Product Change Notification / LIAL-16UCZH910

CCB 4732 Final Notice: Qualification of MMT as an additional assembly site for selected MCP6031, MCP6033, MCP6002, MCP6231 and MCP6241 device families available in 8L DFN (2x3x0.9mm) package.

CCB 4732
Pre and Post Change Summary
PCN#: LIAL-16UCZH910

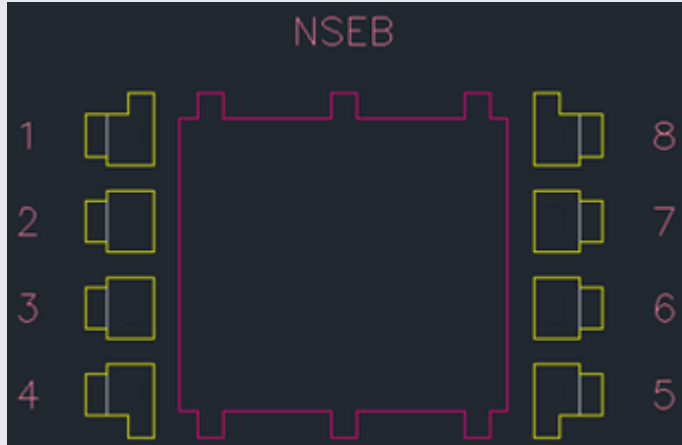
Pre Change

NSEB

Lead frame material	EFTEC-64T
Lead frame DAP surface prep	Ag
Lead frame lead-lock	No

Lead frame comparison

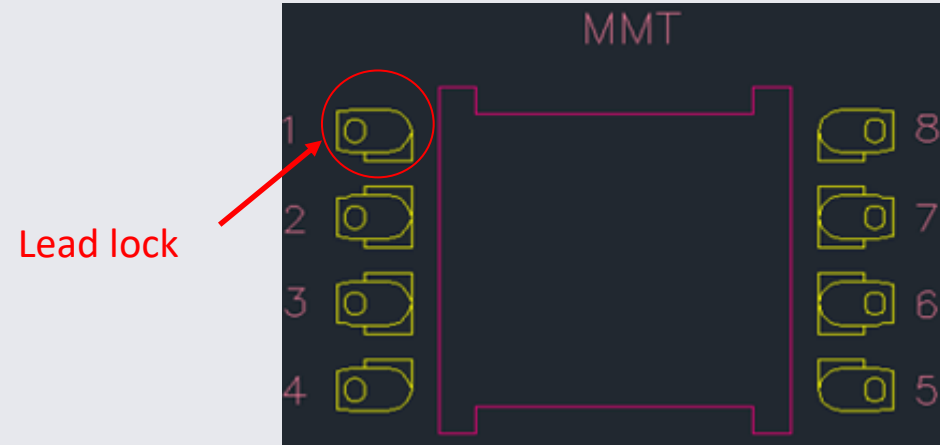
Post change

MMT

Lead frame material	C194
Lead frame DAP surface prep	Bare Cu
Lead frame lead-lock	Yes

NOTE: Mold compound material fills the [lead lock hole](#), which provides improved protection against moisture penetration along the edge of the leads (pins) of the package.
